**ECONOMIC COMMISSION FOR EUROPE  
INLAND TRANSPORT COMMITTEE  
World Forum for Harmonization of Vehicle Regulations (WP.29)  
Working Party on General Safety Provisions (GRSG)**

PROPOSAL FOR DRAFT AMENDMENTS TO REGULATION No. 107

Transmitted by the Expert from Germany

**Figure 8b**

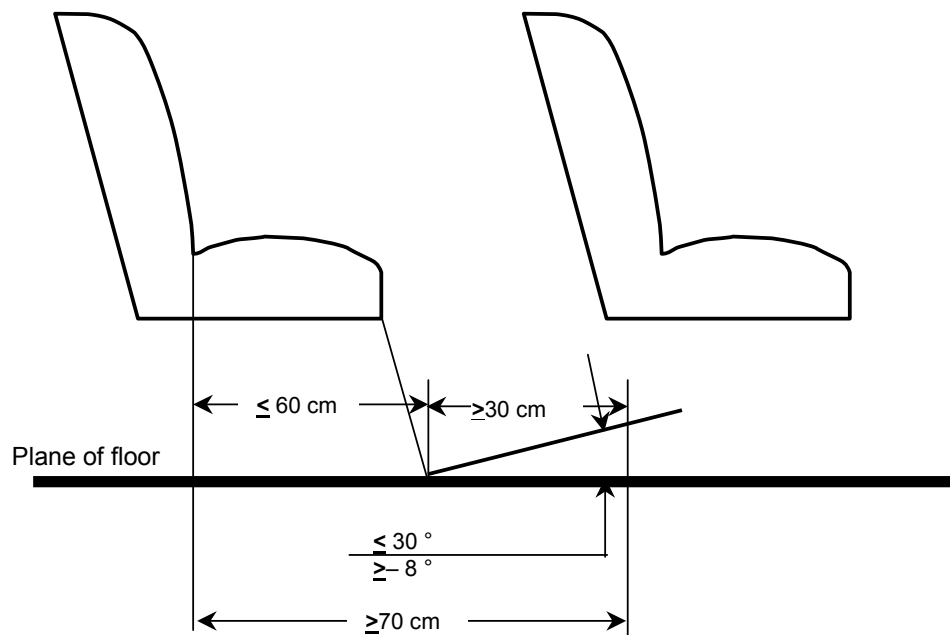
**"5.7.9.5.2. For a seat behind a seat and/or a seat facing the gangway, a minimum clear foot space of at least 300 mm depth and a width according to paragraph 5.7.9.1.1., shall be provided as shown in Annex 3, figure 8b. The local presence in this space of seat legs and of intrusions as provided by paragraph 5.7.9.6.2.3 shall be permitted provided that adequate space remains for the passengers' feet. This foot space may partly be situated in and/or above the gangway but shall not create any obstruction when measuring the minimum gangway-width in accordance with paragraph 5.7.5. "**

Insert a new drawing:

**"Space for seated passengers behind a seat and or/ or a seat facing the gangway"**  
(see paragraph 5.7.9.5.2)

1. to clarify the interpretation of paragraph 5.7.9.5.1. and Annex 3 figure 8, which was intended not to impose any additional requirements on seat spacing but instead to determine the clear space between a passenger seat and a partition or other rigid structure other than a seat, and
2. to clarify that the foot space in front of each passenger seat may be so located such that parts of the foot space "intrude" into the gangway, either on the floor or above it. In any case, while measuring the gangway width with the respective testing gauge, the foot space shall not obstruct movement of the gauge.
